DART SERVICE INSTRUCTION

TO AMEND INSTALLATION INSTRUCTIONS II135-21 REV. J AND INSTRUCTIONS FOR CONTINUED AIRWORTHINESS ICA135-21 REV. F OR LATER APPROVED REVISIONS

The purpose of this service instruction is to support deviations with installation of Dart Cable Cutter 647,7307

FIGURE 1- UPPER CUTTER INSTALLATION

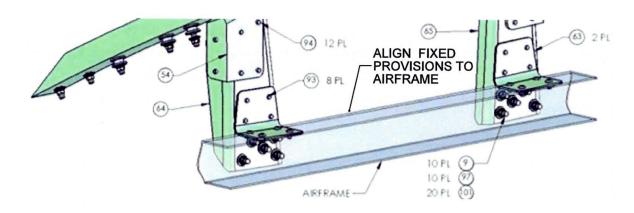
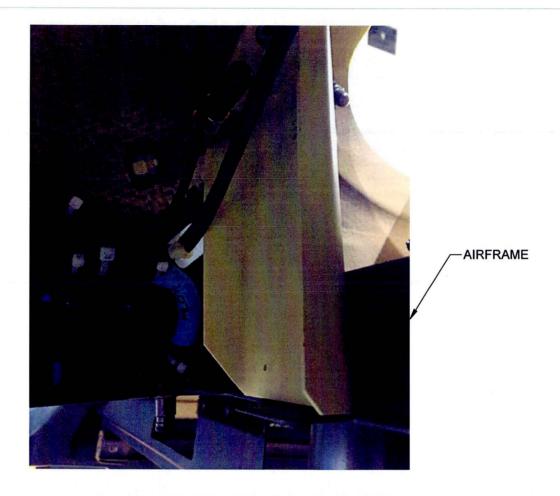
Issue: The Installation Instructions for the upper cutter indicate that the forward edge of the upper cutter rail should be installed at STA 2323.0. However, it appears that the upper cutter should be moved further aft to align with the aircraft structure.

Solution: It is acceptable to move the upper cutter further aft so that the 647.7917 (F/N 64) and 647.7918 (F/N 65) Brackets sit flush with the existing channel on the aircraft as shown in Figure 1 and Figure 2. The STA lines provided in the Installation Instructions should be treated as reference locations only.

FIGURE 3 - INTERFERENCE BETWEEN 647.2114 AND 647.7823

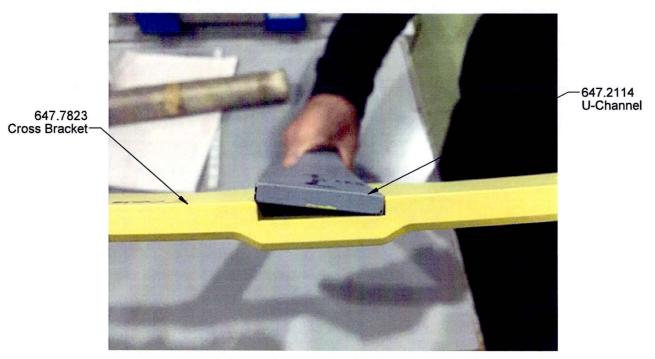
Issue: The 647.2114 U-Channel does not fit into the 647.7823 Cross Bracket. The Cross Bracket has a 33.0 mm recess and the U-Channel is approx 0.6 mm wider. See Figure 3.

Solution: It is acceptable to relieve the 647.7823 Cross Bracket to improve the fit of the 647.2114 U-Channel. Ensure there are no sharp edges/corners. Touch up finish with alodine and primer in accordance with Dart ICA135-21 and/or the Aircraft Maintenance Manual.
